Greater Dublin Drainage Project Addendum

**Environmental Impact Assessment Report Addendum:
Volume 3A Part B of 6**

**Appendix A13.5 – Responses to Traffic and Transport Questions at
the 2019 Oral Hearing**

**Response to Roads Issues Raised on behalf of Gannon
Properties and Response to Roads and Traffic Issues Raised
by Sabrina Joyce Kemper**

Figure 1 Extract from Planning Drawing 32102902-2120 showing proposed WwTP access Road on the line of the indicative North-South Link Road provided by Fingal County Council

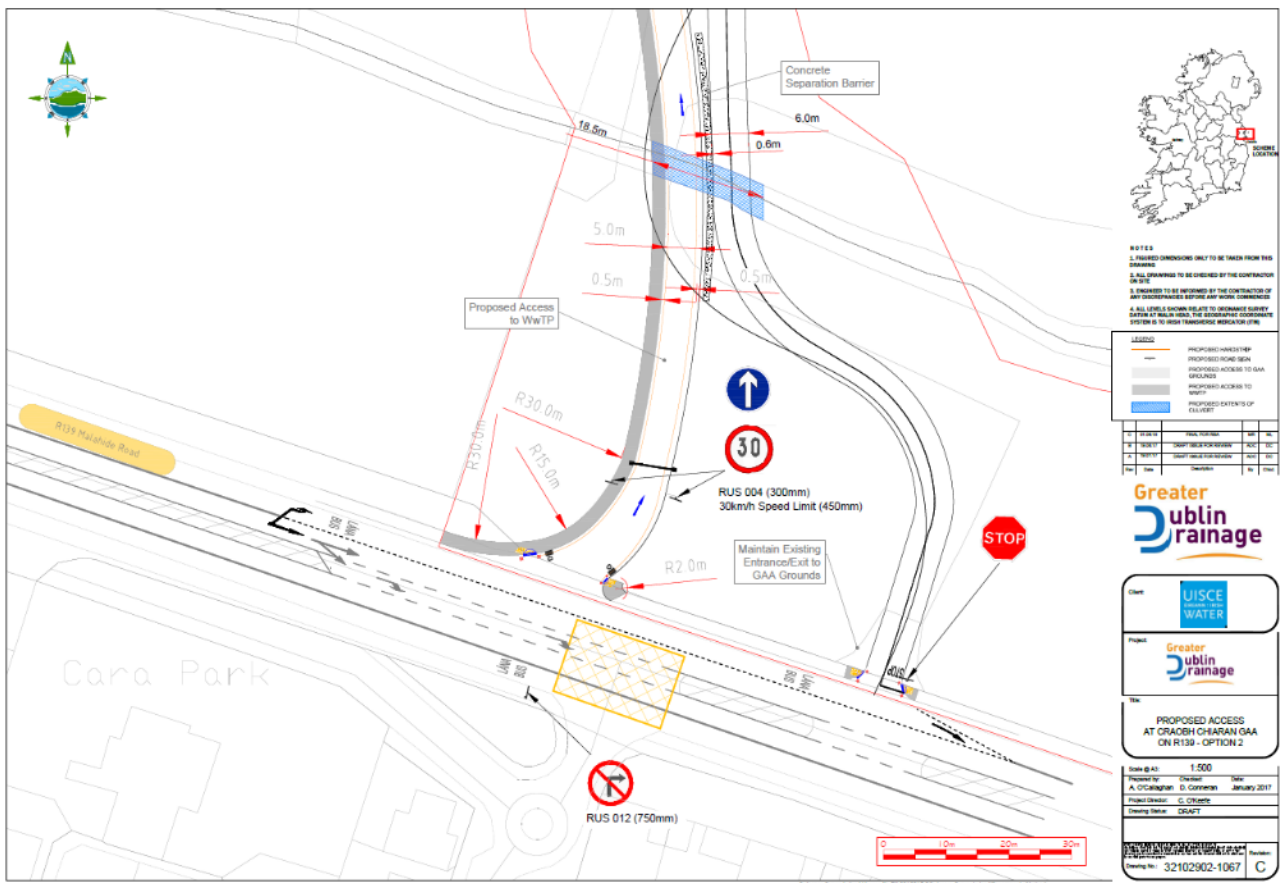
- 6 It is proposed that the western kerb line of the proposed access road be fixed along the kerb line of the outline North-South Link Road and construct a 5.0m wide carriageway to the east side, with a 2.0m wide footway to the west side of the kerb line. By following the line of the western kerb line, the construction of the proposed WwTP access road will not prejudice the FCC objective of the future North-South Link Road. If the North-South Link Road is developed over time, the proposed access road being fixed to the western kerb line, will ensure that the WwTP access can be maintained whilst road construction work to the east side of the access road can take place to construct the road cross section that will be determined by FCC as their plans for the area develop.

- 7 The design of the proposed WwTP access road is such that it will not prejudice the future link road. Road construction as shown on planning drawing 32102902-2205 shows a typical road construction comprising 250mm thick of bound materials (surface, binder and base layers) on a road foundation of 150mm thick layer of granular Clause 804 material on 180mm thick granular capping material. Should permission be granted for the development, the exact road design detail will be agree with Fingal County Council and Dublin City Council.

Figure 2 Extract from drawing 32102902-1067 showing extent of culvert.

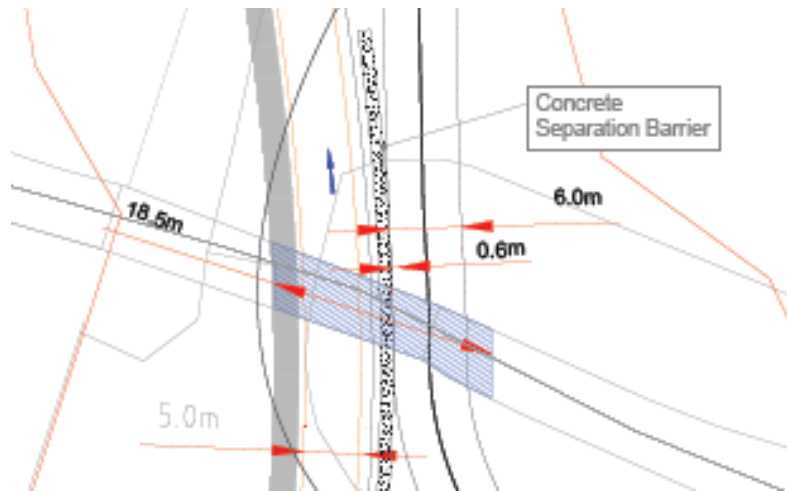
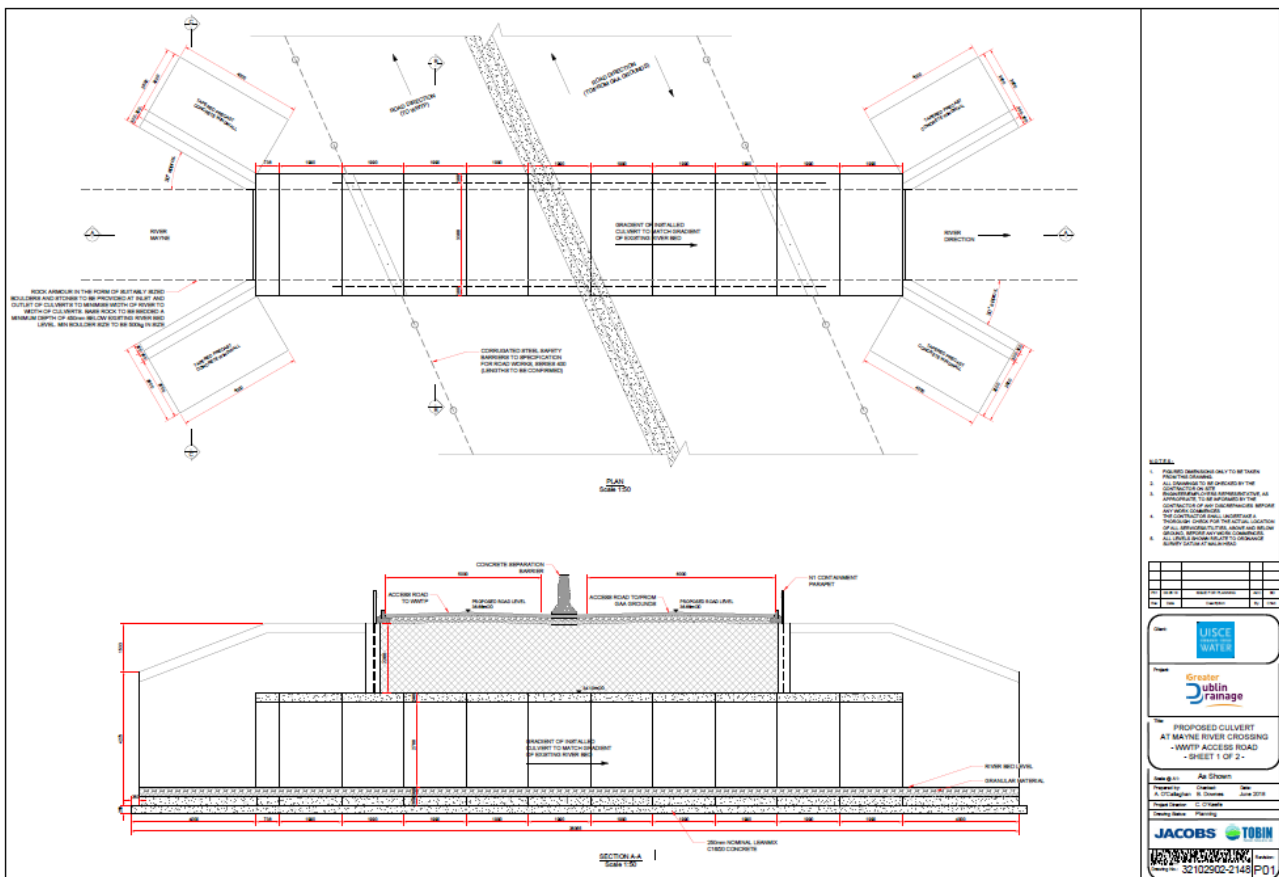
- 11 The observer has stated the applicant be conditioned to construct the Mayne River Culvert to the distributor road standard.
- 12 I can confirm that the application for the Proposed Development includes the construction of the Mayne River Culvert to facilitate both the proposed one-way WwTP Access Road and the adjacent Craobh Chiaráin GAA club access road proposals. This is shown as the blue hatched area on drawing 32102902-1067 included with Appendix 2 - Appendix A Part 2 of the Construction Environmental Management Plan.

- 13 The length of the proposed Mayne River culvert shown on Planning Drawing 32102902-2148 will also facilitate the indicative cross section of the FCC future North South Link Road (i.e. 17.5m wide back of footway to back of footway, comprising 2m footway, 1.5m on road cycle lane, 3.5m northbound traffic lane, 3.5m reserve / turning lane, 3.5m southbound traffic lane, 1.5m cycle lane and 2.0m footway).
- 14 It is acknowledged that as the future North-South Link Road cross section is indicative, the future road width may be subject to change as the development plan is advanced. Should a wider future road cross section be required, the culvert can be widened by removing the eastern headwall and extending the culvert units the necessary additional width.
